# Arabi Fashion Ltd (Extension)

# Observations

**Prepared DEA report needs to be revised**

# Apparently inadequate connection

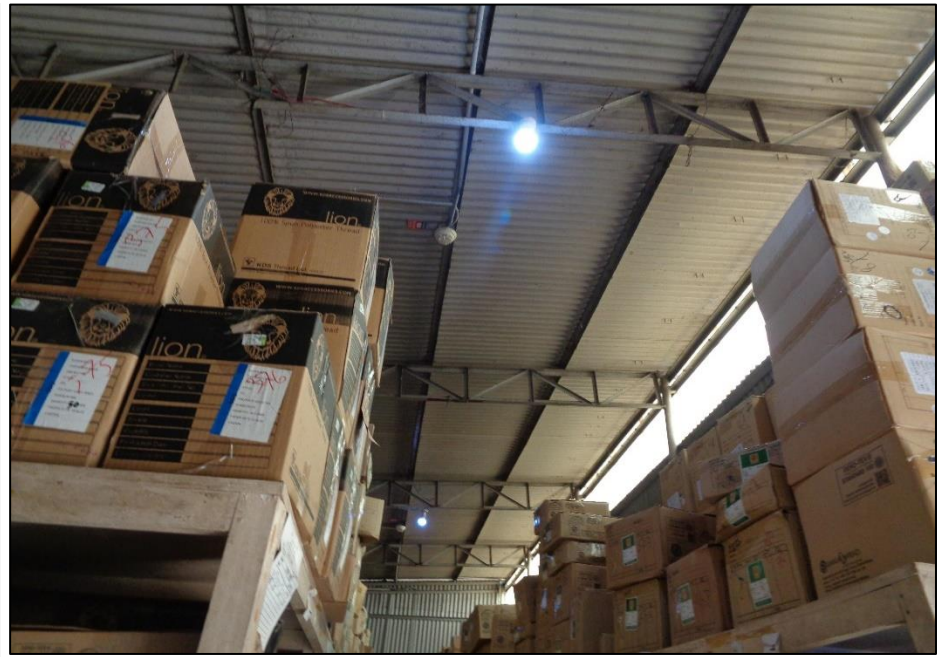
Poor connection details

Apparently inadequate structural members

The steel roof shed is made of angle sections and supported by brick wall over the staircase. Apparently inadequate structural member, poor connection details found. Building engineer is required to check the adequacy of the steel members & connections for gravity and lateral forces and suggest necessary alternatives.

Item No.	Observation	Recommended Action Plan	Recommended Timeline
01	Prepared DEA report needs to be revised (Dining Building)	Building engineer to update the DEA documents including a DEA report, based on verifying in-situ concrete strength in compliance with BNBC-2006.	6-weeks
02	Prepared DEA report needs to be revised (Dining Building)	Complete implementation of any remedial works deemed necessary by the Design Report.	6-months
03	Possible future extension (Dining Building)	Prior to any type of extensions/expansion or modifications of the existing building, a Detail Engineering Assessment (DEA) by a structural Engineer needs to be carryout in compliance with the BNBC.	6-months
04	Possible future extension (Dining Building)	Carry out remedial works from outcome of DEA where necessary before commencement of further construction.	6-months
05	Non-engineered roof shed over staircase (Dining Building)	Building engineer is required to check the adequacy of the roof shed for gravity and lateral forces or replace with the engineered sheds.	6-weeks
